## SERVICE BULLETIN

SB98.2

**Machines/Models: MX 15/19**

**PURPOSE:** Reposition Down and Tilt alarm.

Figure 1

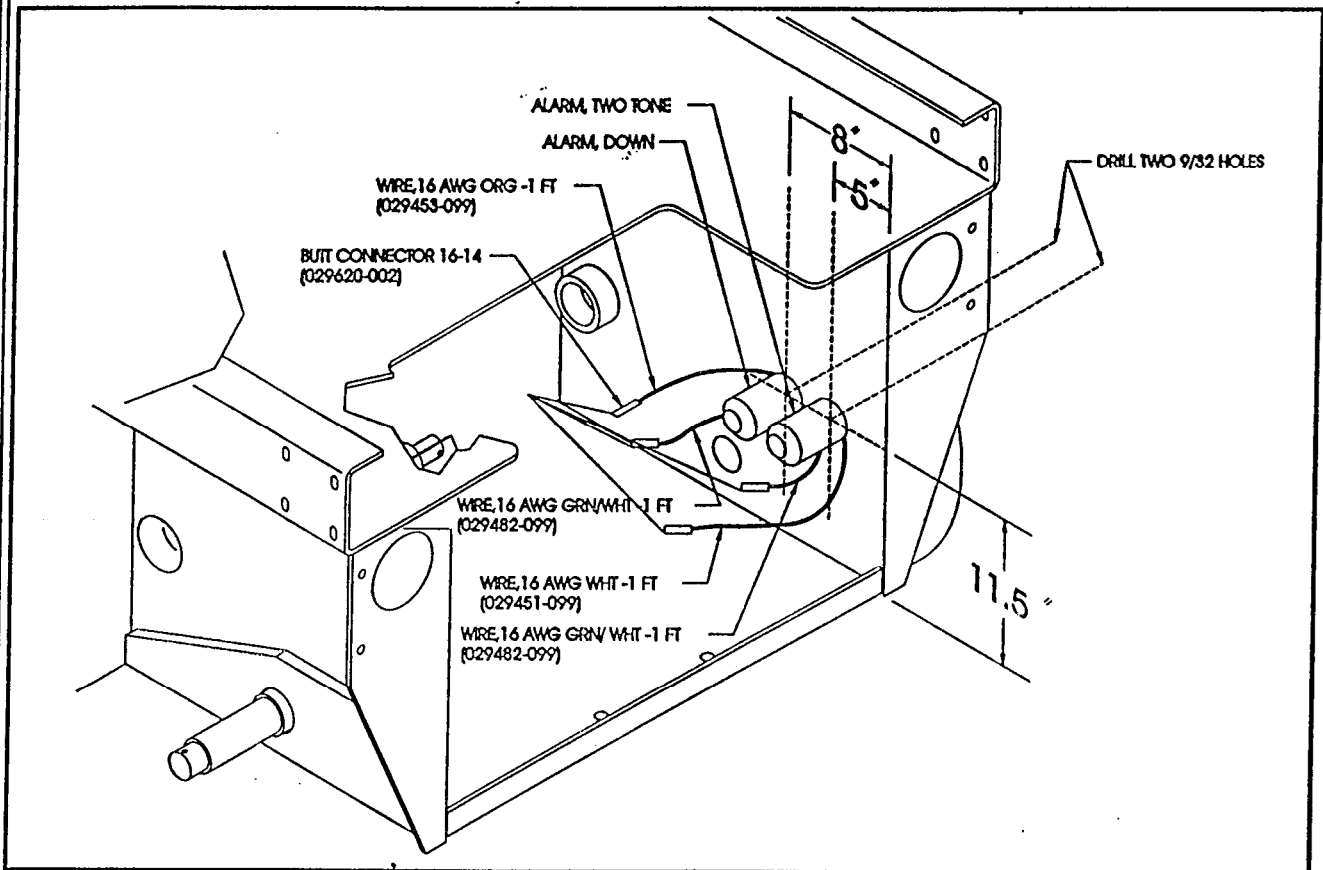
1. Locate area for Down and Tilt alarm installation. (figure 1)
2. Drill two 9/32 holes as shown. (figure 1)
3. Remove Down and Tilt alarm retaining bolts.

4. Locate Down and Tilt alarm to new location, install retaining bolts.  
**NOTE: If wire length is not sufficient, splice wires, add connectors and wires supplied with kit. (Verify existing wire color matches wires added)**

Figure 3. Tilt Sensor

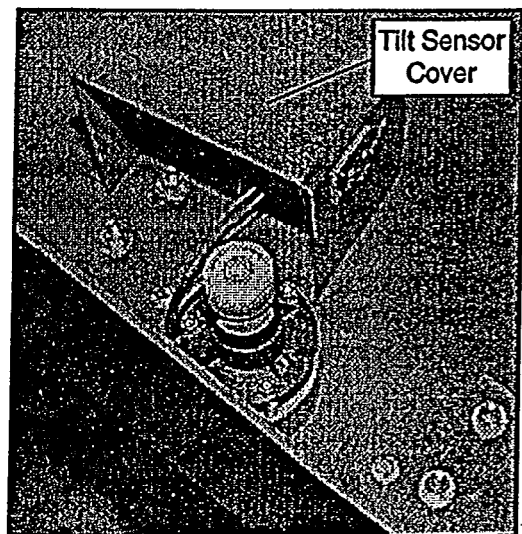
9. Rotate scissor brace to a vertical position. Lower platform until end of scissor arm weldment rests on brace.
10. Remove tilt sensor cover retaining screws. (figure 3)

11. Push tilt sensor (indicate) off level, tilt alarm should sound. (figure 3)
12. Reinstall tilt sensor cover and retaining screws. (figure 3)
13. Position Chassis Lift Switch **UP** and elevate platform approximately seven feet. (2.1m)
